MILITARY TECHNICAL BULLETIN

SUBJECT: Webbing modification for CSAV SCUBA Strap Kit PN 769091

- **Affected Units: CSAV Units manufactured before 07/09 utilizing the Mariner Kam-Pac or the Mariner Twin Pack SCUBA attachment system**
- **Problem: Strap slippage of CSAV SCUBA Strap Kit PN 769091**

Figure 5

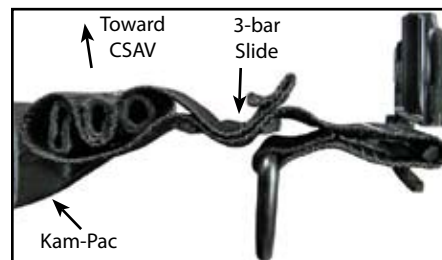
Aqua Lung has informed Production Dept. to amend all manufacturing instructions to include a sewn end fold on all webbing used in sewn diving products. All webbing used for PN 769091 will receive a 1/2" sewn end fold, leaving an approximately 1/4" butterfly (Figure 2). The webbing will be threaded such that if the webbing slips, it should catch on the center bar of the slide adjuster (Figure 3). Straps should be weaved through the Kam-Pac/Twin Pack as designed (Figures 4 & 5). Owners of affected units may make these changes on site if desired. As always, local command instructions/directives take precedence over manufacturers recommendations.
